NORTHERN BEACHES LOCAL PLANNING PANEL

WEDNESDAY 14 APRIL 2021

Agenda for the Northern Beaches Local Planning Panel to be held on Wednesday 14 April 2021

Figure 1: Easements relating to Lot 15. Annotated to help identify the location of easement 'G1'.

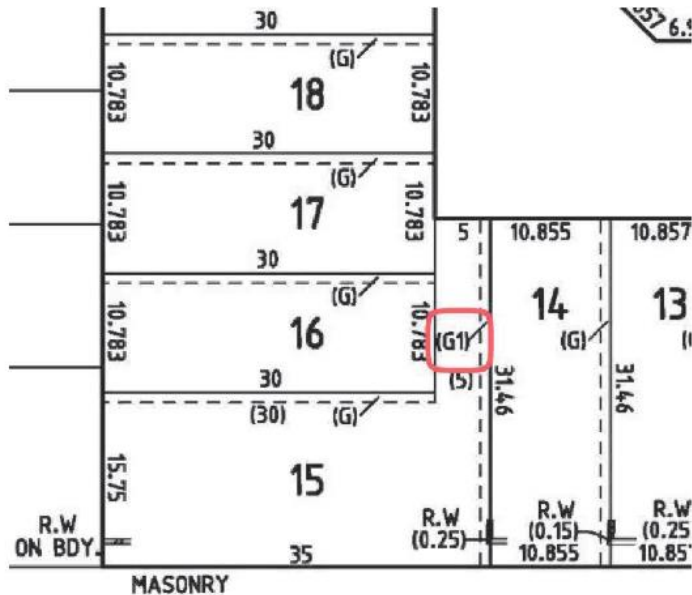
The site (Lot 15) is burdened by Easement 'G1' as specified within the Section 88B Instrument and

The proposal however indicates part of the carport and covered entry encroaching within this area (shown in red below on Figure 3).

Figure 5: Solar access diagrams at June 21.

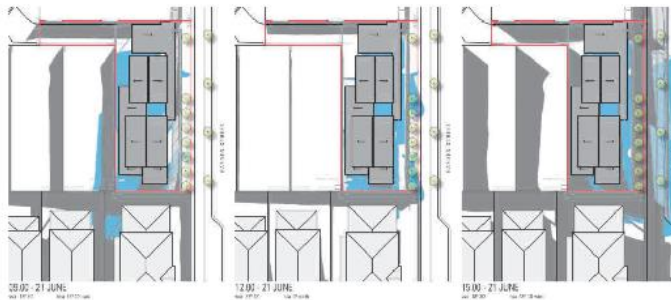
The proposed development is also seen to breach the requirement for a minimum of 3 hours solar access being provided to the private open space area (rear garden and patio) for adjoining property to the south, No. 2 Orchard Street, Warriewood. Whilst No. 2 Orchard Street, Warriewood is currently an 'exhibition home', the assessment has taken into consideration solar access impacts to this property for any future residents.

Section 1 (source SWA Group)

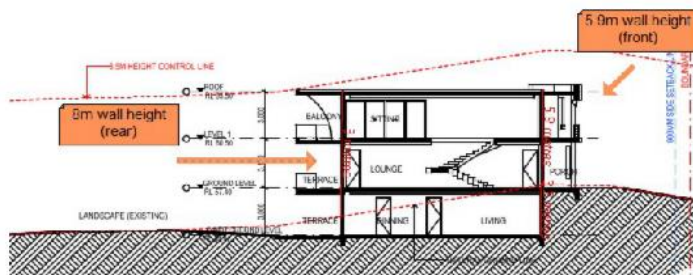
The proposal will result in a 9% (0.8m) breach in the 7.2m wall height towards the rear (north) and a 25% (1.8m) breach to the eastern side of the proposed dwelling.
